NUMBER: 08-014-05

Mopar Accessory Remote Starter Inoperative Due To Hood Switch

This bulletin involves replacing the hood switch for the remote starting system.

Fig. 1 HOOD SWITCH LOCATION - TYPICAL

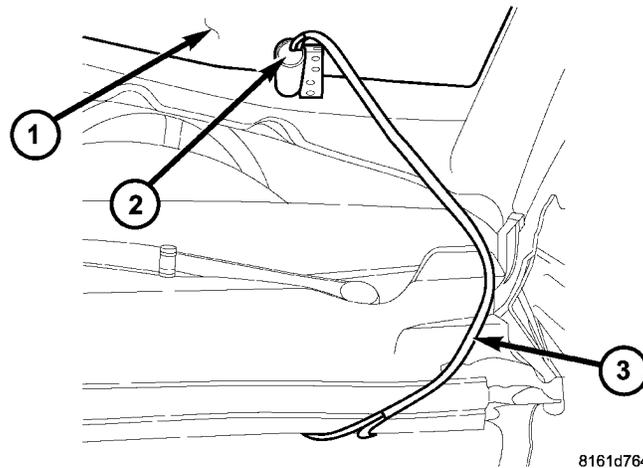
1. Open the hood.
2. Disconnect and isolate the negative battery cable.
3. Locate and disconnect the ground lead for the hood switch at the cowl.
4. Locate and disconnect the soldered joint on the other wire to the remote start hood switch.
5. Remove the remote start hood switch.(Fig. 1).

-
6. Install the new hood switch, p/n 05140473AA.
 7. Solder the appropriate wire to the remote start hood switch back into the vehicle wiring harness. Refer to the service information available in TechCONNECT. Reference: Service Info, 8 - Electrical/Wiring Diagram Information/Wire - Standard Procedure - Wire Splicing.
 8. Connect the ground lead for the hood switch at the cowl.
 9. Connect the negative battery cable and reset the clock.
 10. Close the hood.
 11. With key and remote in hand, insure all the doors are closed and locked.
 12. From outside the vehicle, press the transmitter button to remote start the engine. The vehicle should "chirp" once and then start. If the vehicle engine starts, no further action is necessary.
